May 19, 2017  
Job Number: 2186-002  
Design Review and Rehabilitation Plan for  
534 N. Kenwood Street, Glendale, CA 91203

**MEMORANDUM FOR THE RECORD**

SUBJECT: Design Review and Rehabilitation Plan for 534 N.  
Kenwood Street, Glendale, CA 91201

A4.4

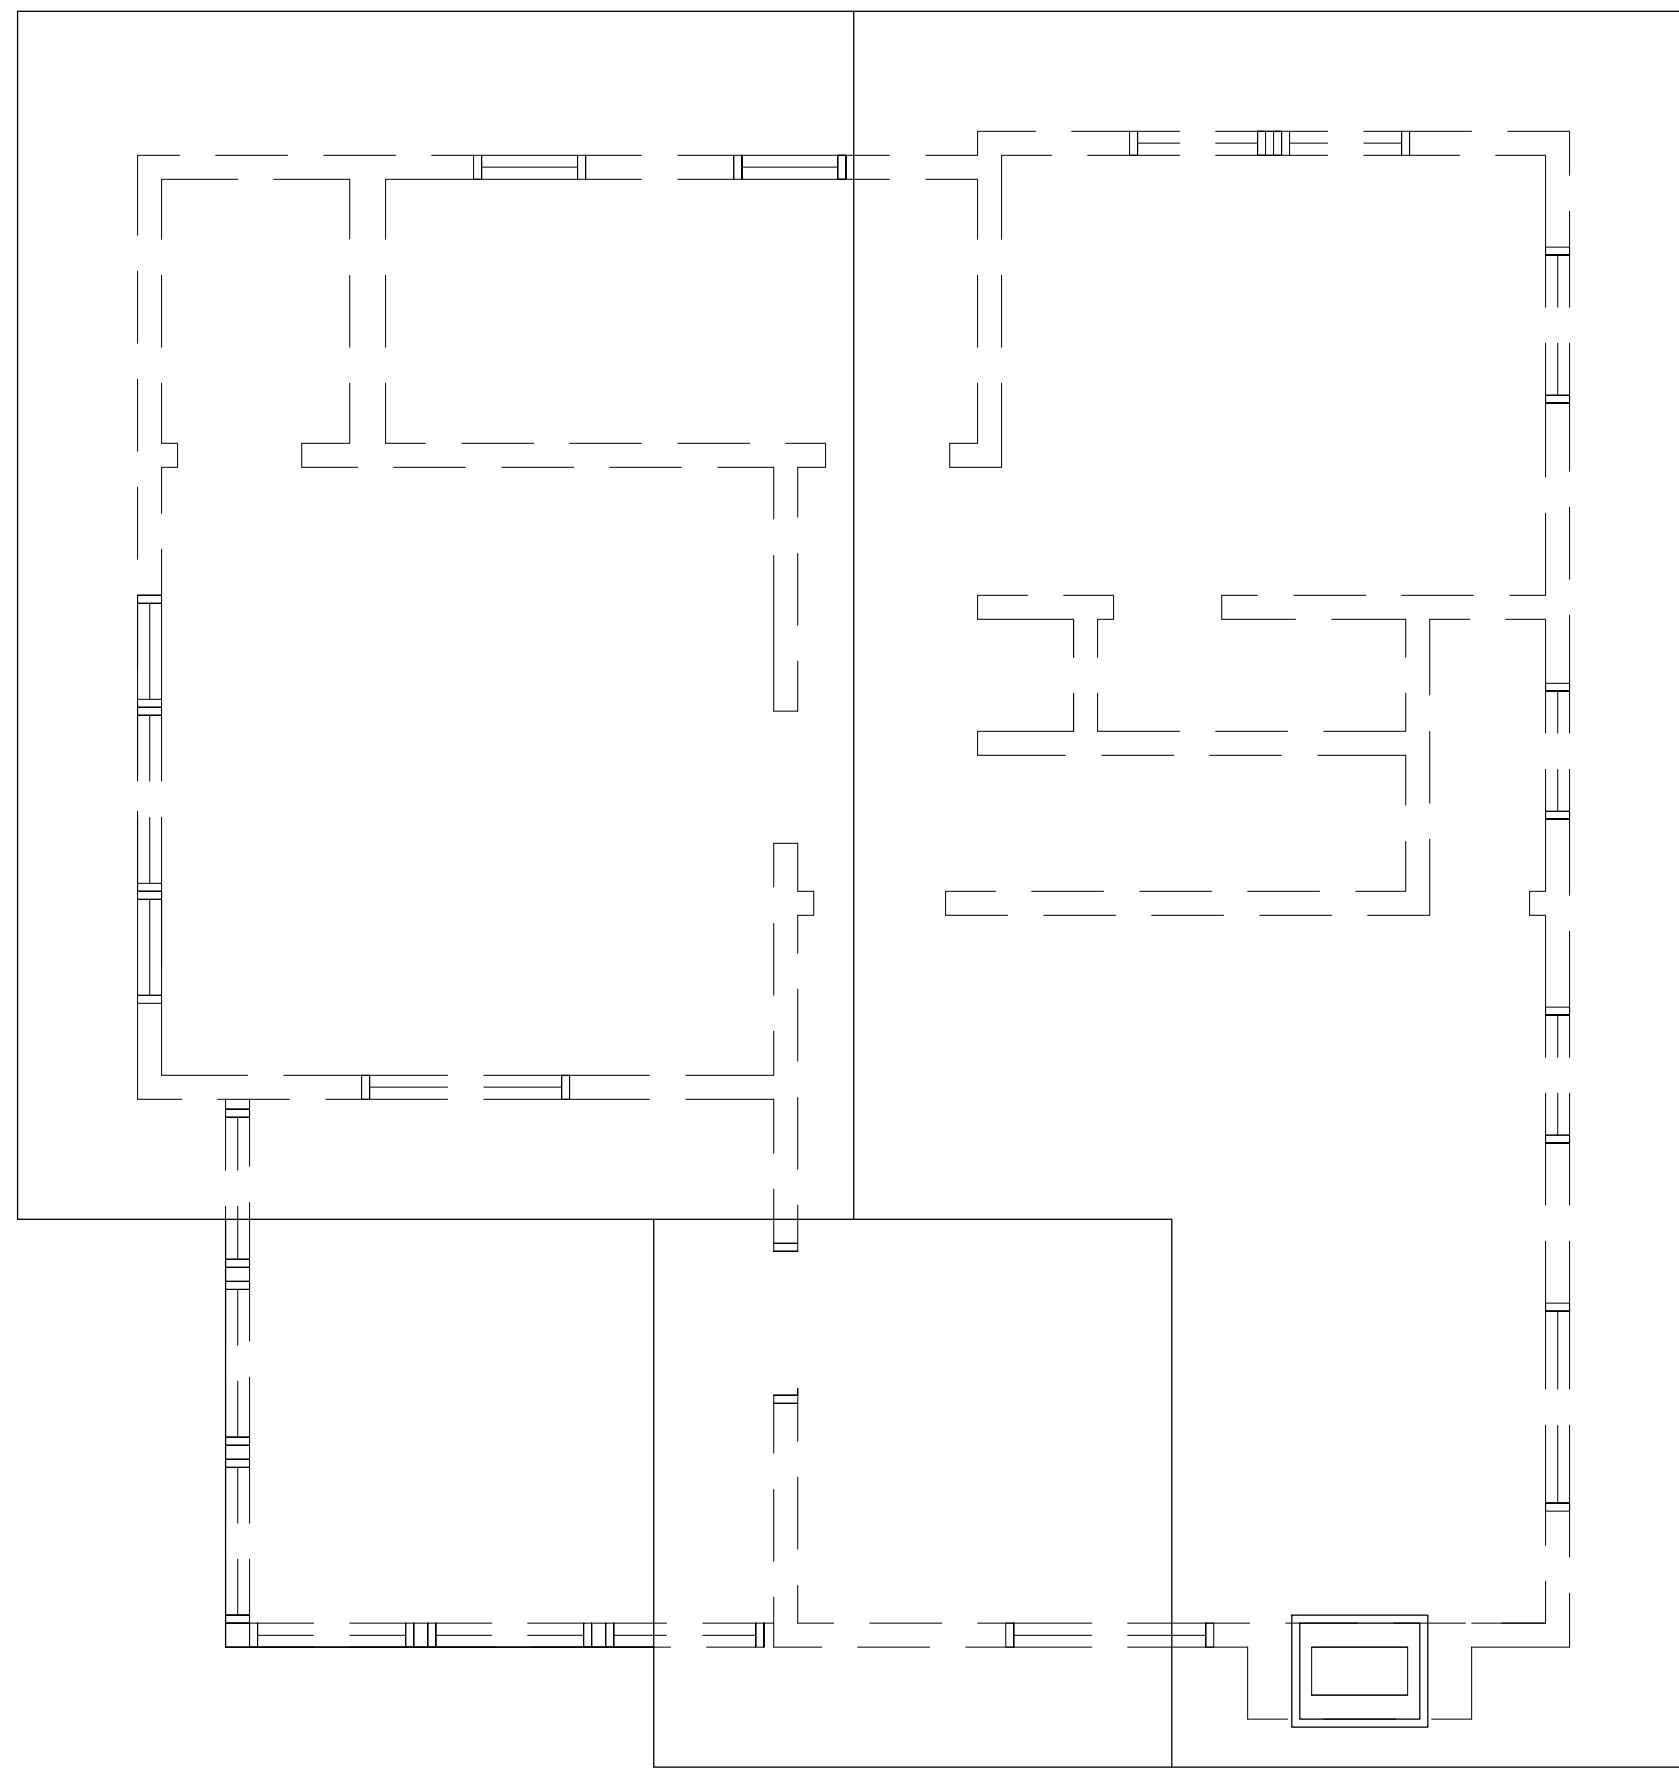
The primary façade of the building would be restored through the repair of the windows with the decorative and unique muntin windows, French doors, primary entry, and repair of the concrete porch and piers. The building will retain and repair its existing roof form, shingles siding, and one-

over-one sash and casement windows to the extent feasible or replace in kind. Windows will be retained and repaired to the extent feasible. All replacement windows will be compatible with the existing window types, sizes, and materials. The fascia boards, rafter tails, and bracing will be repaired to the extent feasible or replaced in kind. Therefore, the project complies with Standard for Rehabilitation No. 2.

The project would repair damaged members to the extent feasible or would replace in kind. The project would remove a 15-light casement window and six window openings in order to convert the rear second floor addition to a bathroom. The replacement materials are in keeping with the existing. Therefore, the building would not be changed in a manner that creates a false sense of historical development which is consistent with Standard for Rehabilitation No. 3.

Although the rear second floor addition is not visible from the public right-of-way, it will be retained and rehabilitated to a different use which is in keeping with Standard for Rehabilitation No. 4.

- City staff will inspect the site during all phases of construction to ensure the project is constructed as approved.
- Period hardware shall be retained and re-used.
- Shingle siding shall be salvaged and re-used to the extent feasible. Replacement shingles shall match existing shingles.
- Damaged stucco and concrete shall be repaired and patched as needed with materials that are consistent with existing concrete in terms of color, scoring, and aggregate size as appropriate.
- The gutters and downspouts will be mounted to the restored fascia boards in a manner that would be reversible.
- Windows shall be inspected and repaired by a qualified window restoration specialist.

- Provide product specifications and finishes for replacement windows for review by qualified staff from the City of Glendale Community Development Department. Replacement windows shall retain the existing window openings and profiles except as noted on the rear second floor addition.
- Fascia boards, rafter tails, and braces shall be inspected by a qualified restoration specialist. Damaged wood members will be restored using epoxy or other appropriate material as determined by the restoration specialist to the extent feasible. If the qualified restoration specialist determines the damage is too severe to allow for restoration, wood members shall be replaced in kind.
